工程指示 / 要求簡箋(E.I.)

工程指示編號：EI / 3184 / 21

工程名稱：亞皆老街中電

工程項目：佛沙窗 地盤用玻璃 B.M. 大貨 (T1-T3: 22-23/F) (259 件)

DWG NO. : J852-SD-PW-4122 REV. : F

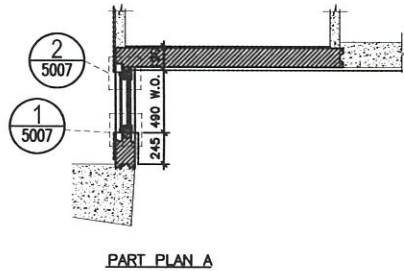
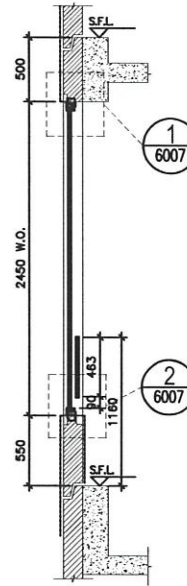
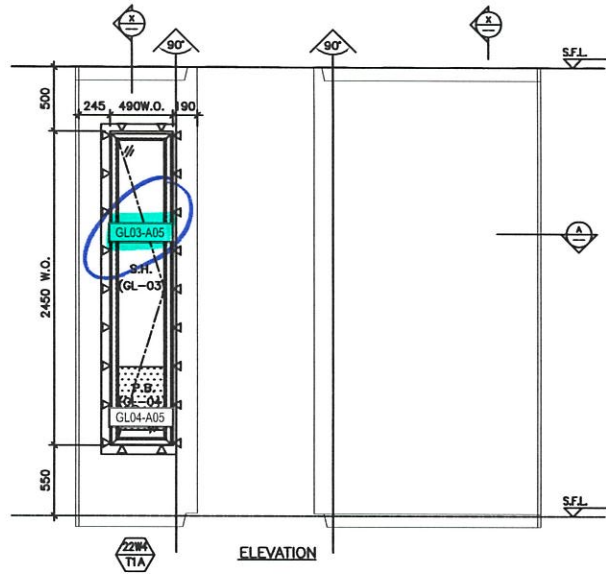
C版：因則師要求修改磨沙玻璃位置，請留意部份改為磨沙的玻璃 (共32件) 暫停出貨。

此位置暫停出貨到地盤。
EI3533A訂購磨砂玻璃取代。

22W4/ T1A 暫停出貨

DWG NO. : J852-SD-PW-4130 REV. : F

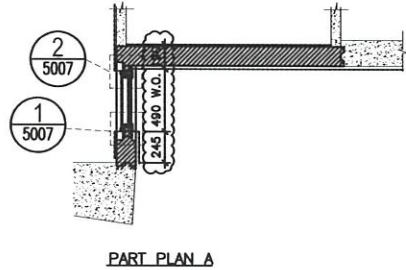
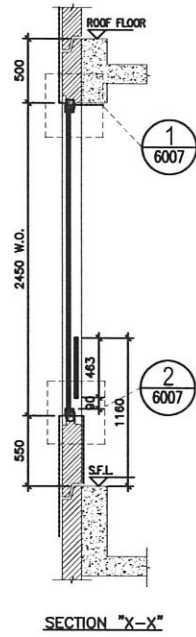
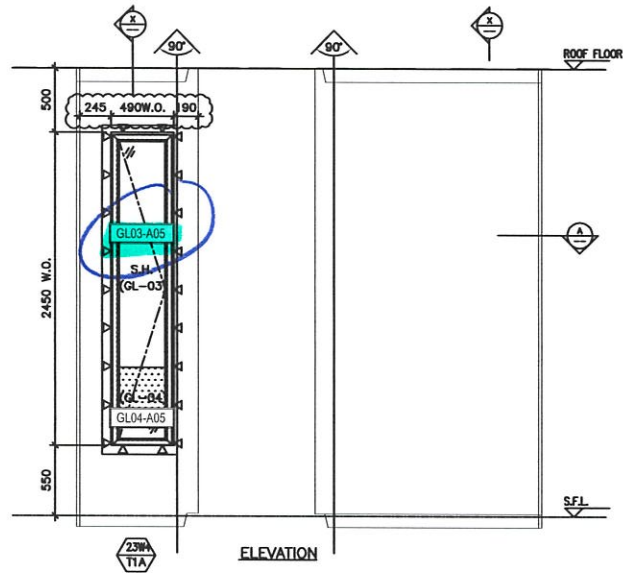
23W4/TIA 暫停出貨

MIDI 英特銘寶有限公司
 英特銘寶有限公司
 810 Che Kwo Ling Road, Kowloon
 Tel: 23488211-4 Fax: (852) 27727868
 DWG NO. : J852-SD-PW-4231 REV. : F

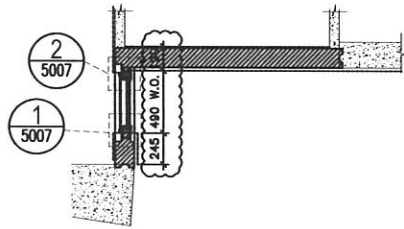
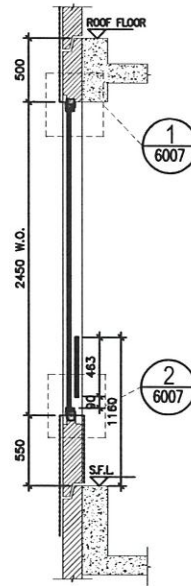
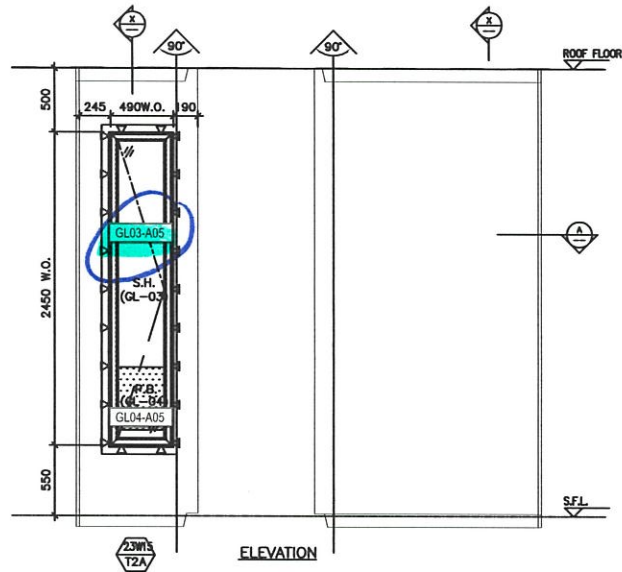
23W15/T2A 暫停出貨

英特鋁質有限公司
MIDI ALUMINIUM FABRICATOR LTD.
Units 6-8, Sunway Industrial Centre, 1/F
610 Che Kwo Ling Road, Kowloon
Tel: 23488211-4 Fax: (852) 2727666
DWG NO. : J852-SD-PW-4321 REV. : F

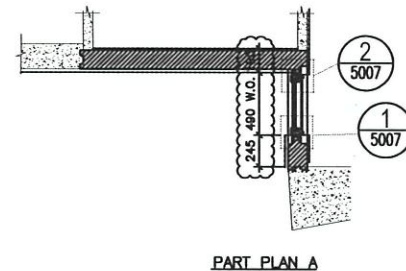
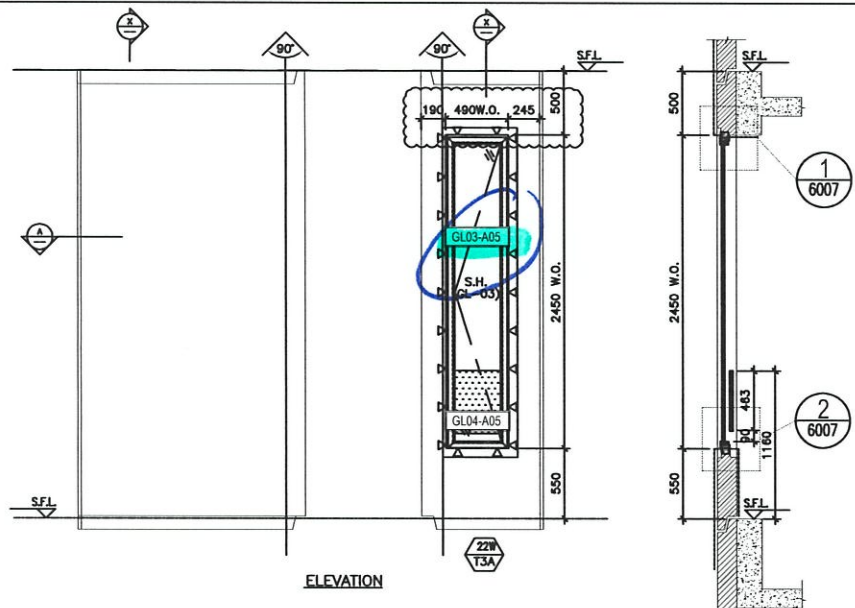
22W15 / T3A 暫停出貨

英特鋁質有限公司
MIDI ALUMINIUM FABRICATOR LTD.
Units 6-8, Sunway Industrial Centre, 1/F
810 Che Kwo Ling Road, Kowloon
Tel: 23488211-4 Fax: 2327272866
DWG NO. : J852-SD-PW-4329 REV. : F

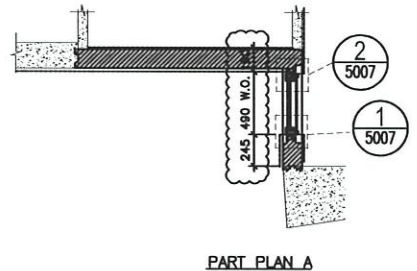
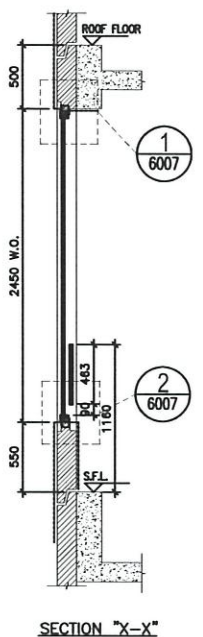
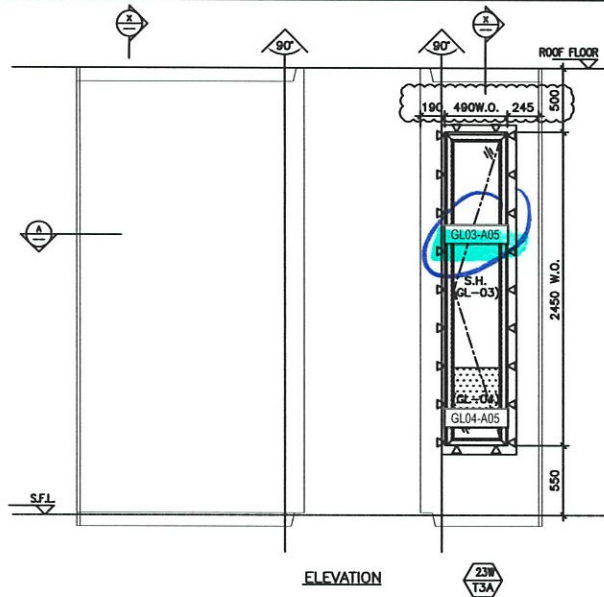
23W15/T3A 暫停出貨

FIRST FLOOR PLAN
(1/F)

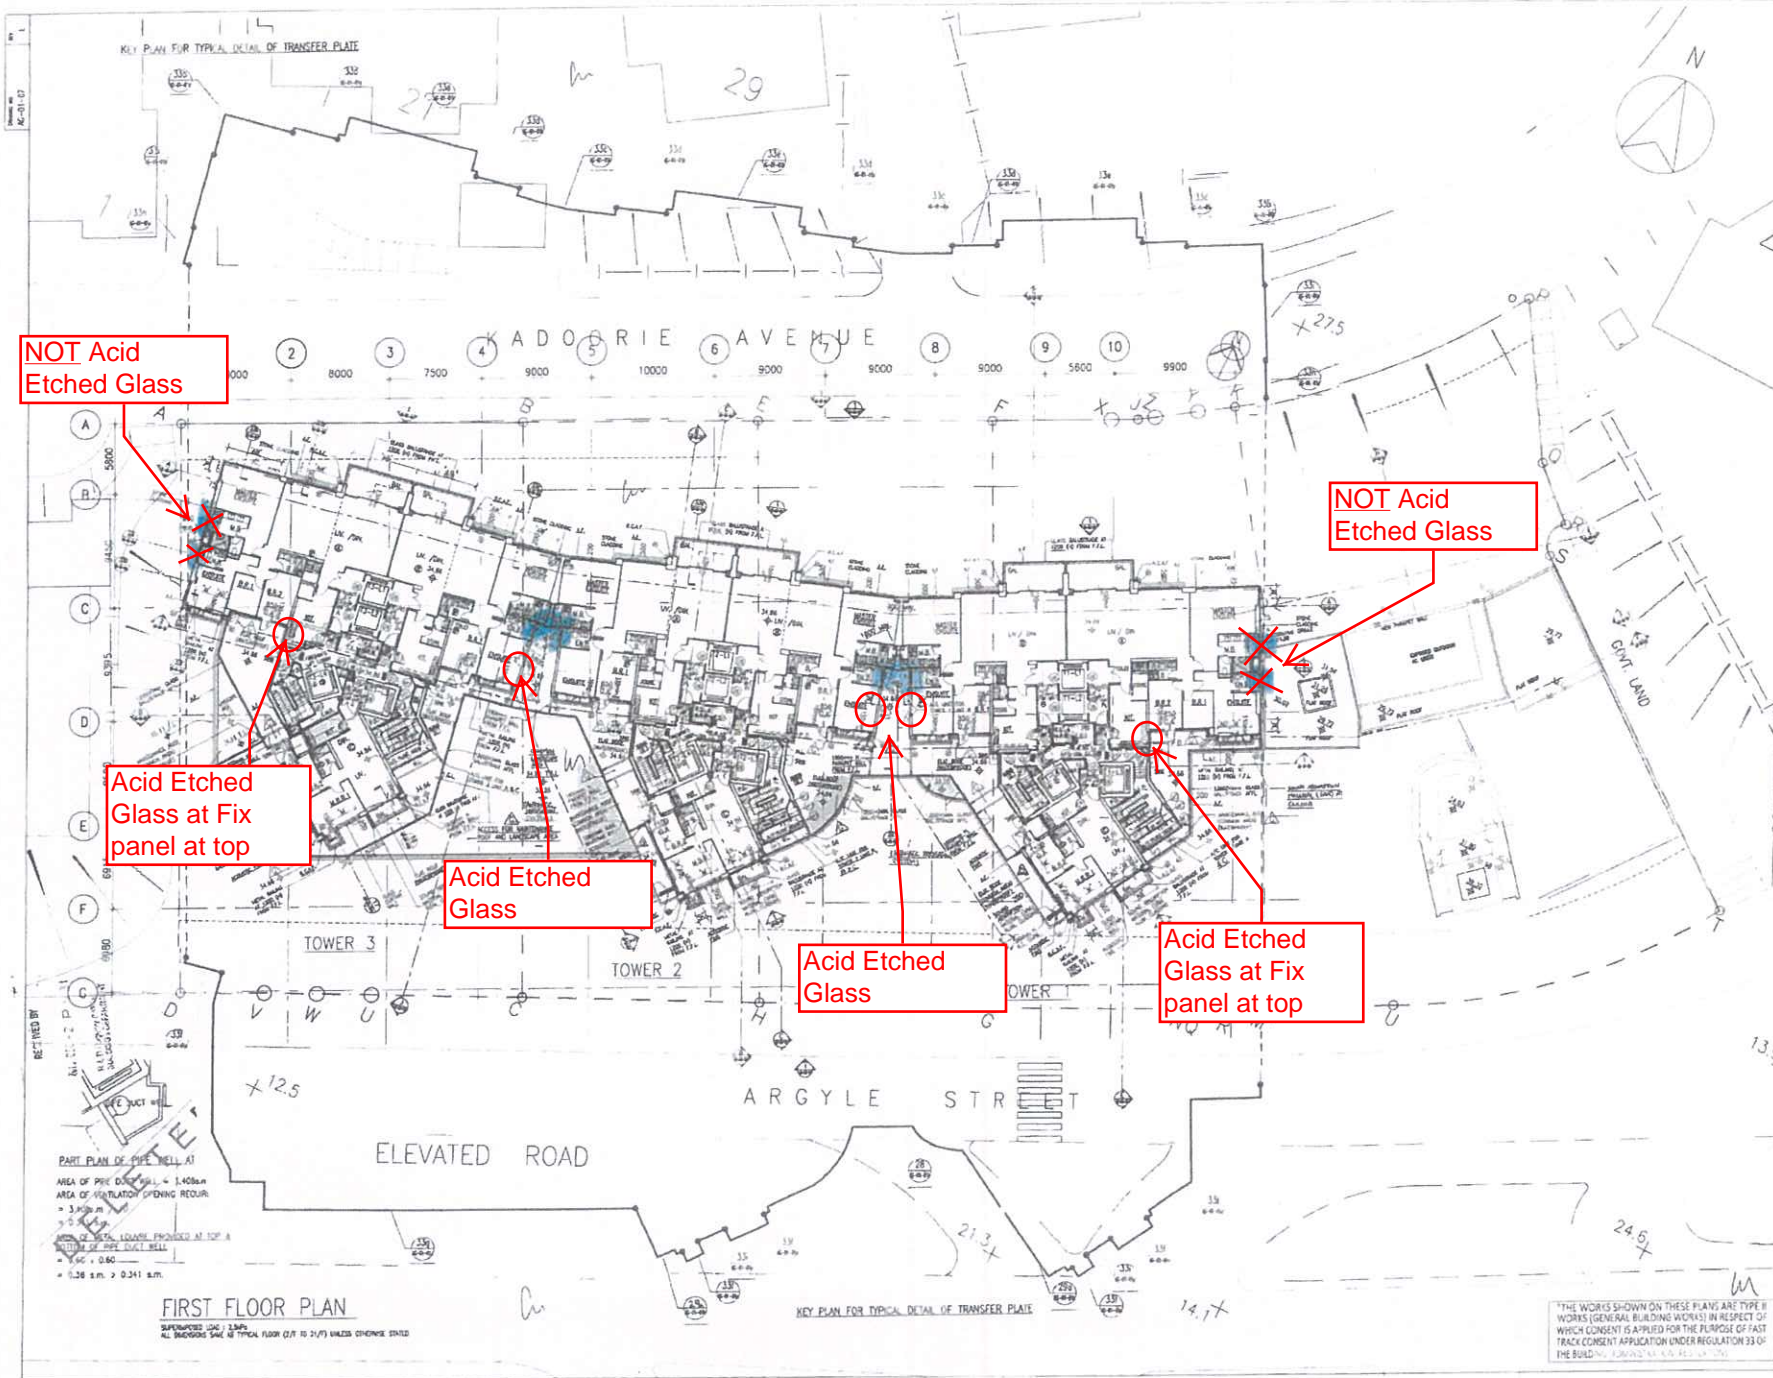
Please note that the location plan of acid etched glass to be used attached in your submission is INCORRECT. Please refer to attached markup for your further action. An updated location plan shall be attached to this submission for our approval.

NOT Acid Etched Glass

NOT Acid Etched Glass

Acid Etched Glass at Fix panel at top

Acid Etched Glass

Acid Etched Glass

Acid Etched Glass at Fix panel at top

TYPICAL FLOOR PLAN
 (2/F to 21/F)
 (SHEET 1)

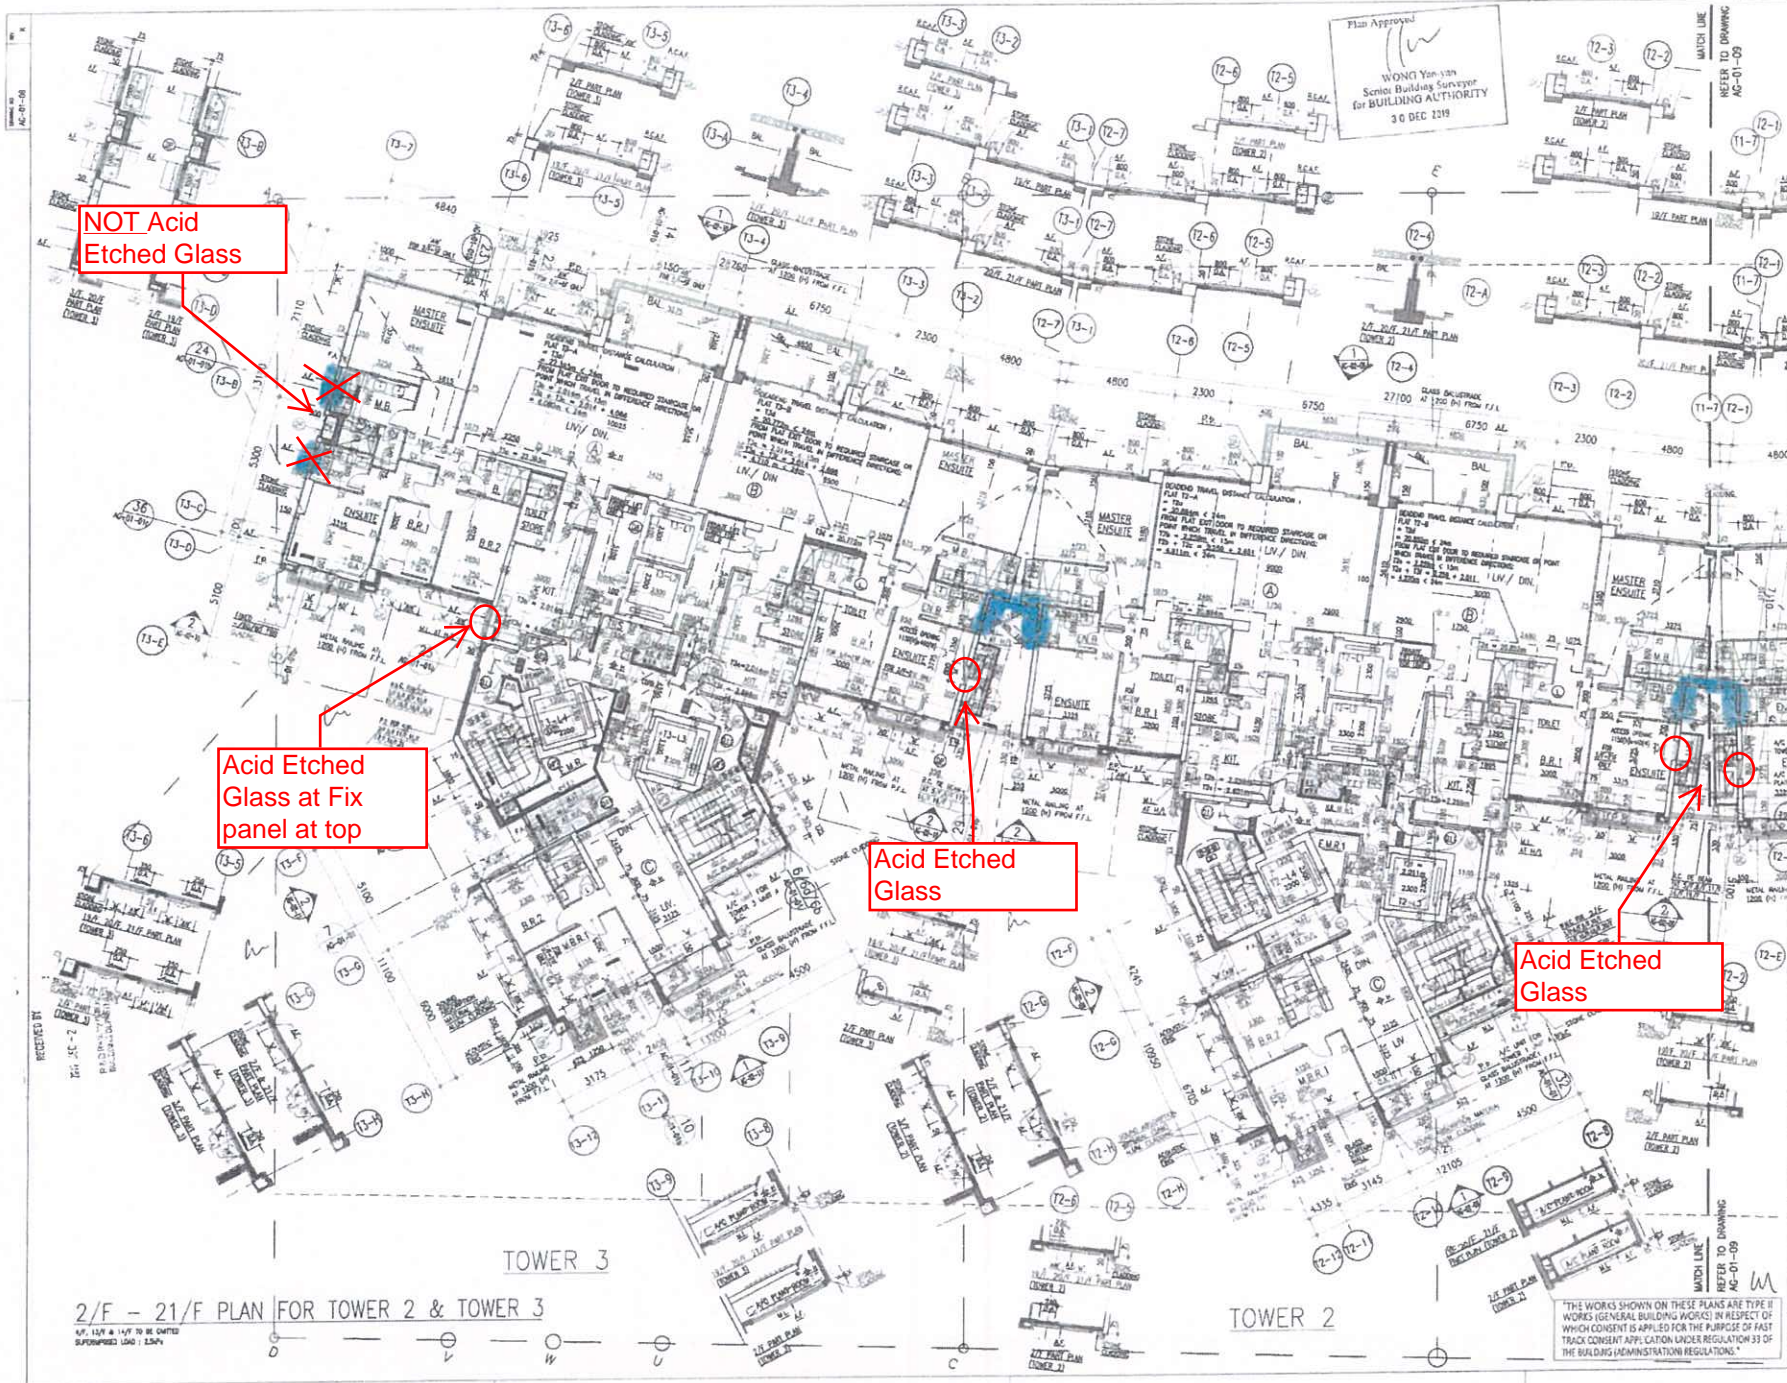
NOT Acid Etched Glass

Acid Etched Glass at Fix panel at top

Acid Etched Glass

Acid Etched Glass
